# Orientation Control System: Enhancing Aerial Maneuvers for Quadruped Robots

Here is a point-by-point response to the reviewers' comments and concerns.

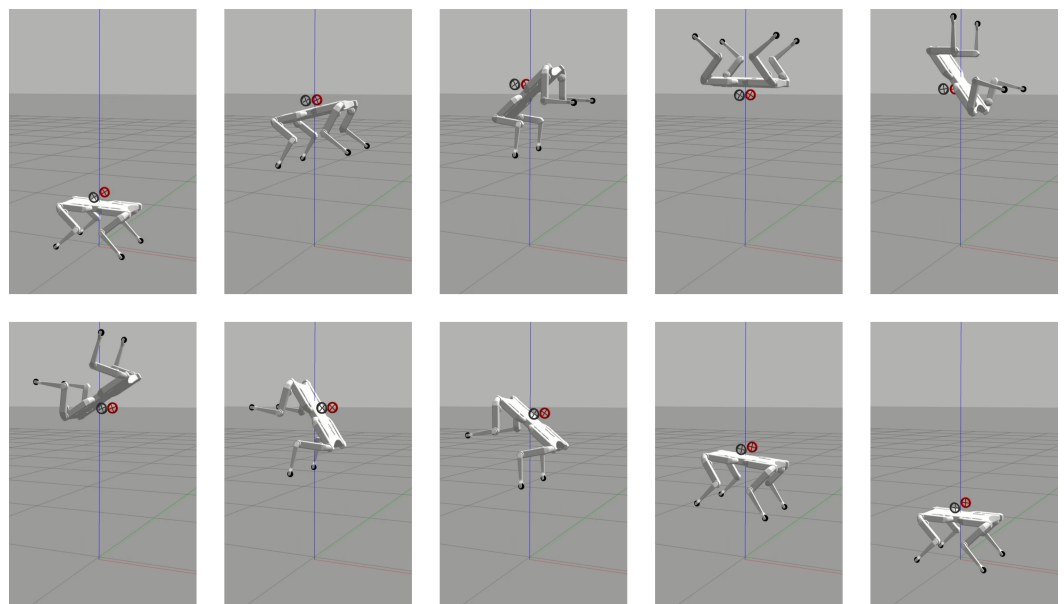
- **Comment 1:** *'All the simulations are performed in Gazebo'. The paper must have more details related with the simulation, including a snapshot of the simulated robot in its environment.*

**Response:** Thank you for the insightful comment. We summarized the details of the simulation in Table 1, which is incorporated to the manuscript too. Moreover, inspired by your suggestion, we attached a sequence of snapshots for the third simulation (back-flip), showing the robot in the Gazebo environment (Fig. 1).
